AUS920010752US1

**D. AMENDMENTS TO THE DRAWINGS**

Applicant submits three replacement sheet drawings (see section F) and requests amendment of the drawings as follows:

FIG. 4

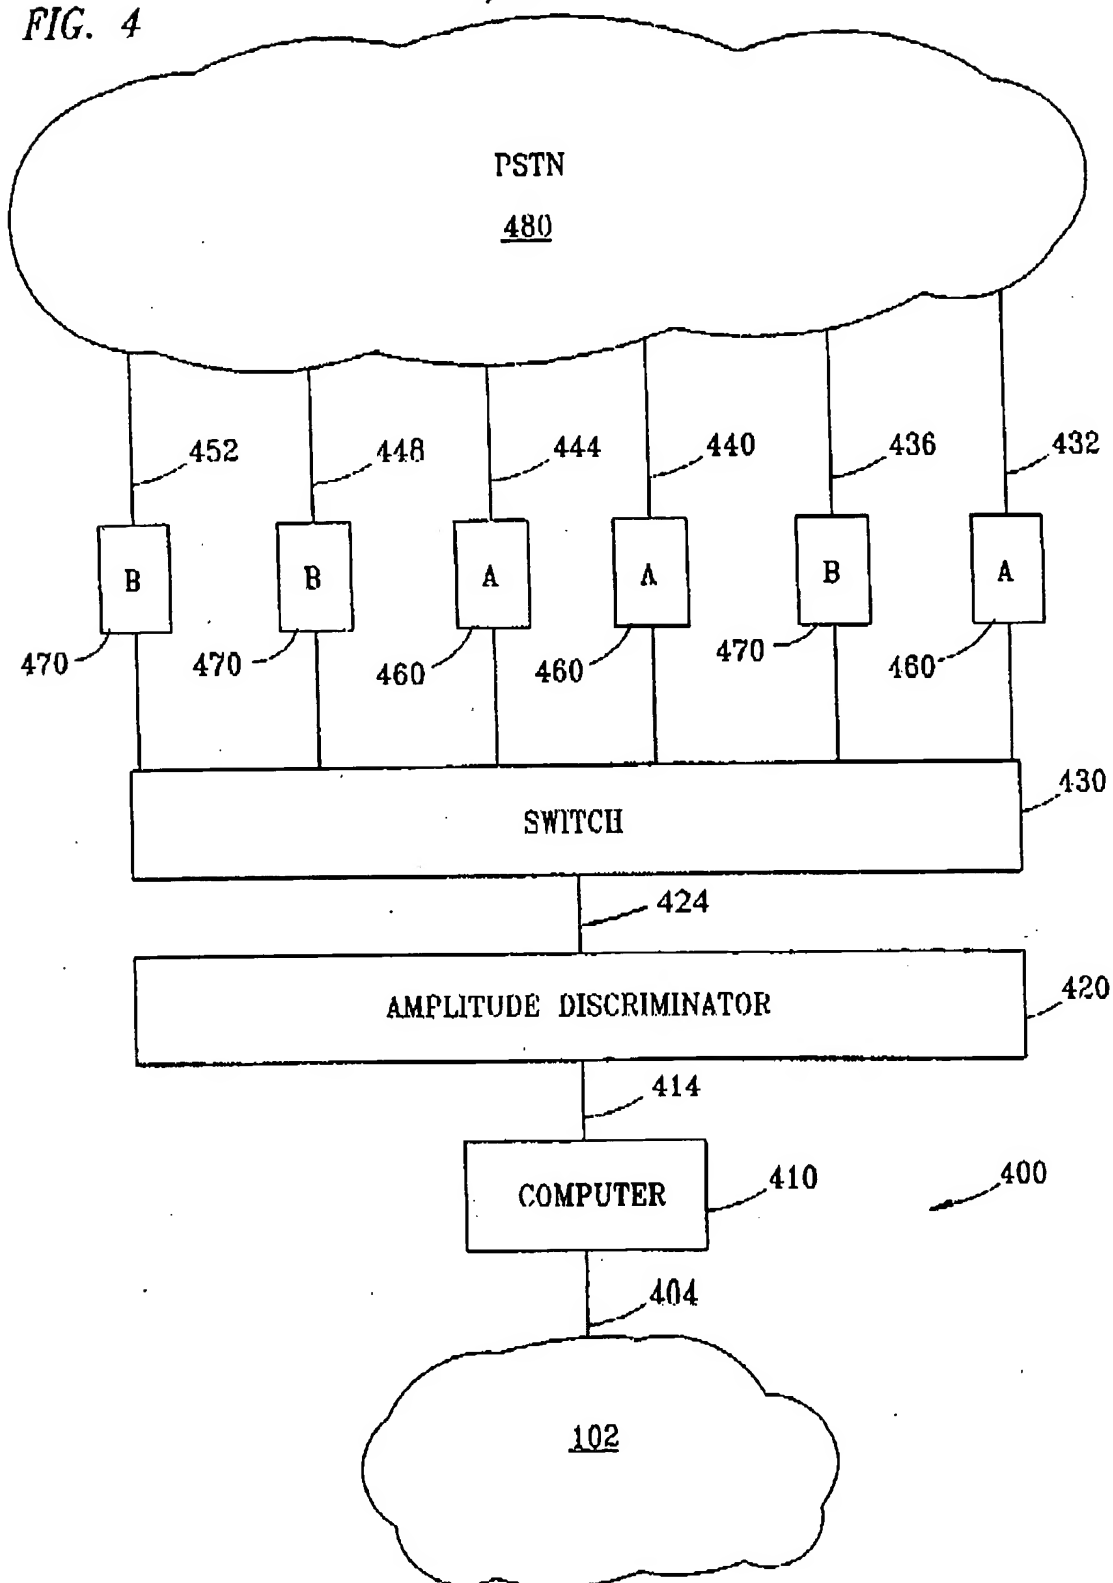
Sheet 3/15, FIG. 4 has been amended to add the numeral 424 to the line connecting switch 430 and amplitude discriminator 420. On page 8, lines 22- page 9, line 1, the specification states "Amplitude discriminator 420 is connected to switch 430 by line 424. The numeral 424 was inadvertently left off the original drawings, and a substitute drawing is provided attached to this response.

FIG. 15

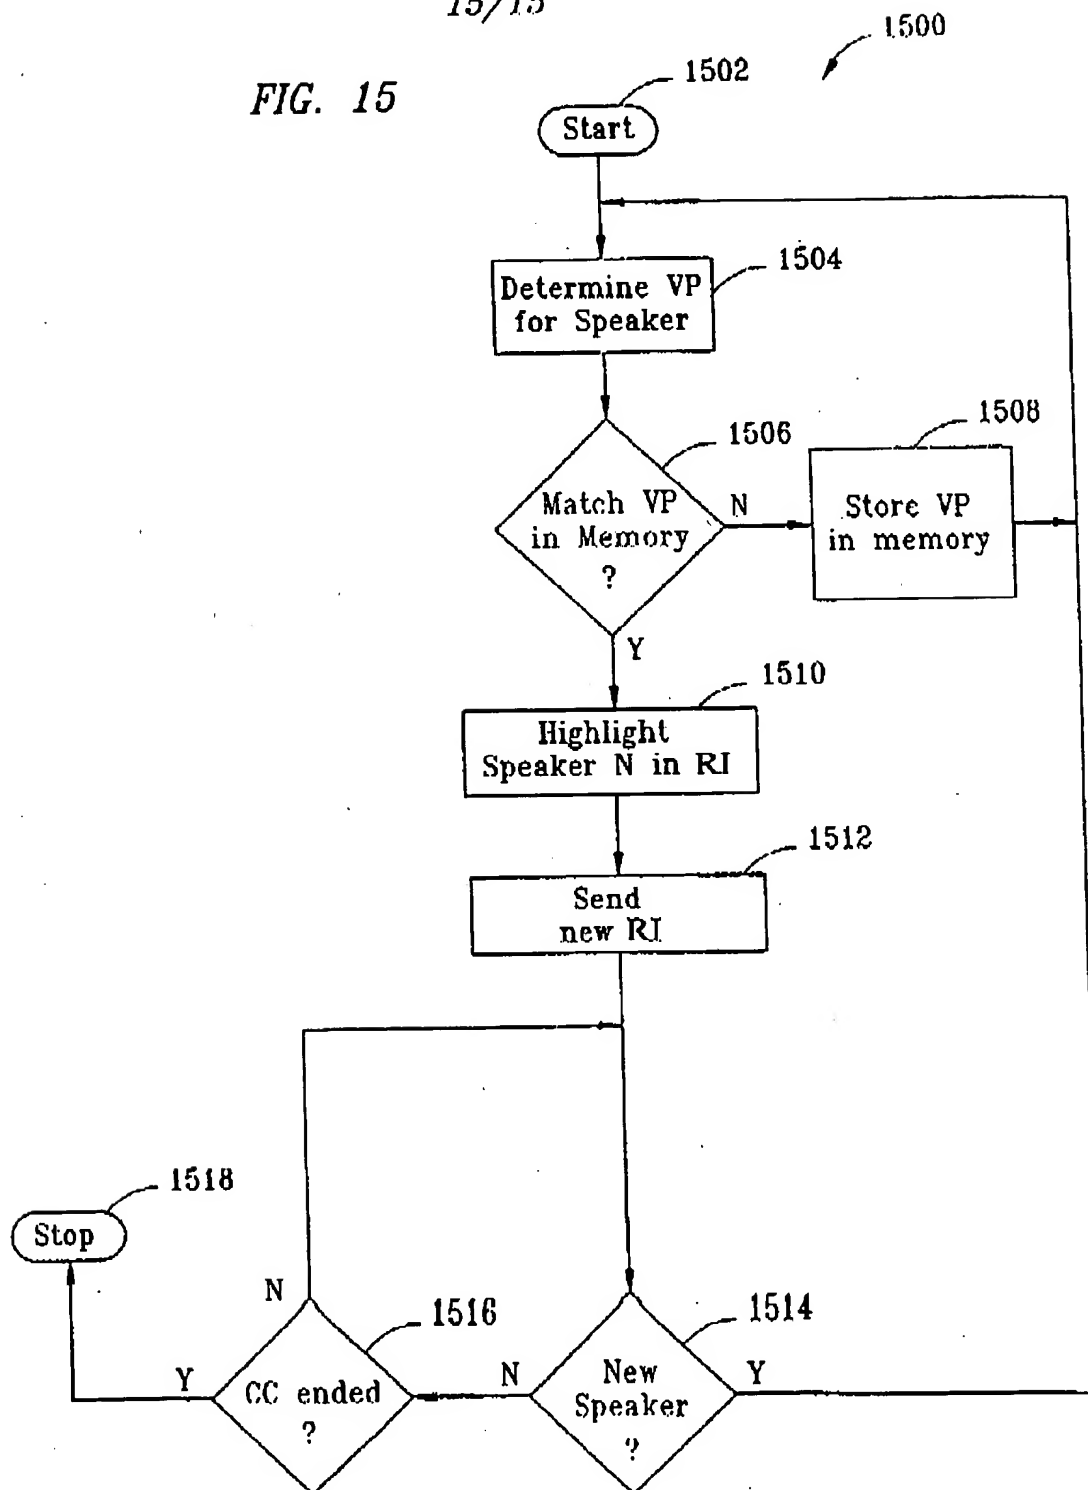
Sheet 15/15, FIG. 15 has been amended to change IP in box 1510 to RI and to change IP in box 1512 to RI. The specification states "in the Roster Information (RI) (1510)" and "a new RI is sent (1512) on page 19, lines 8-9 of the specification. The reference to IP was a typographical error in the drawing and a substitute sheet is provided attached to this response.
